TO: Town of Rutland

RE: CUP 2582 Mineral extraction summary – Flooding concerns

Street view August 2023 – new culvert for cemetery

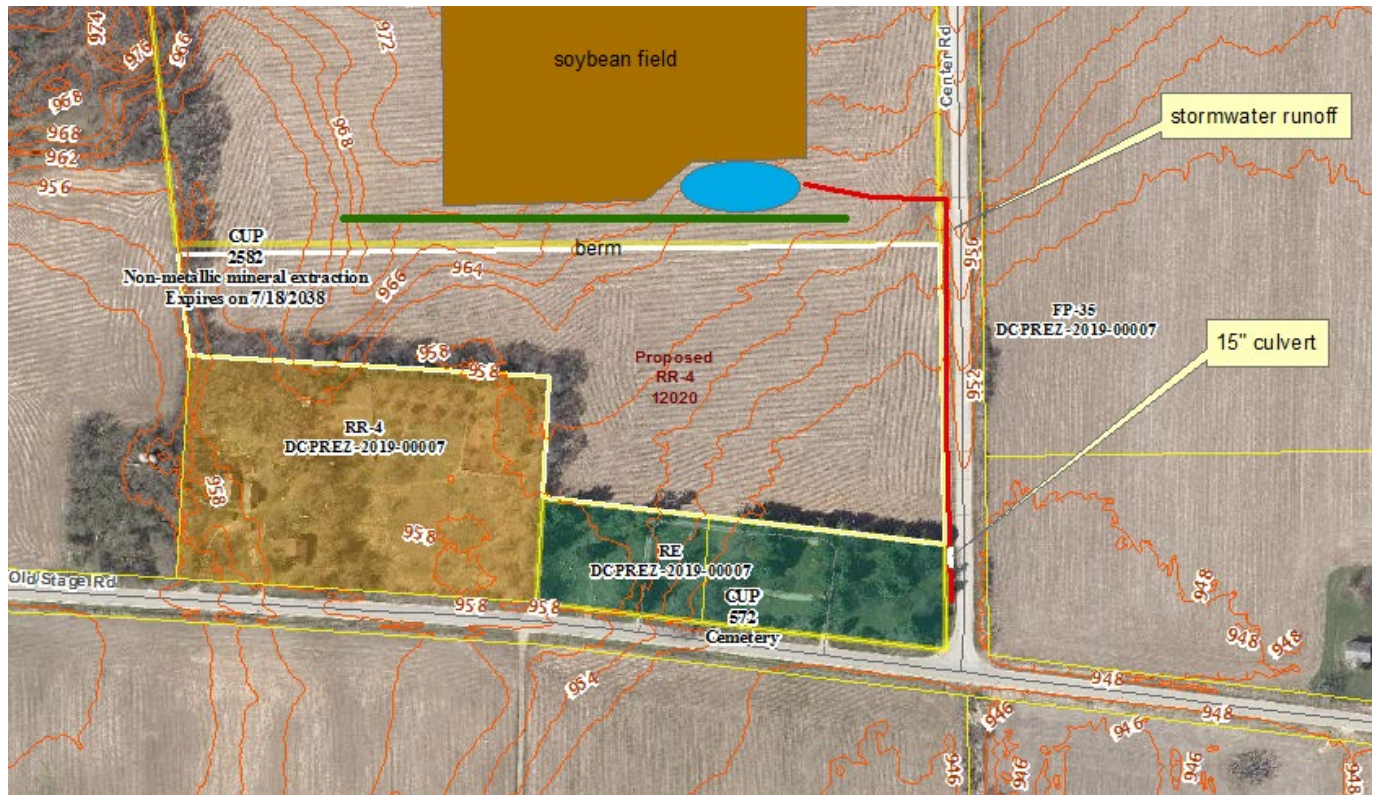
- Surface water running southerly from the adjacent agricultural field (CSM lot) to the north.
- Internally standing water within the cemetery in low areas near the narrow access roads. Water can't leave and either evaporates or naturally drains.
- The newly placed culvert along Center Rd. in my opinion is undersized. It has been somewhat flattened on the south end and slightly damaged on the north side. Perhaps an 18" minimum or even greater diameter pipe should be installed.
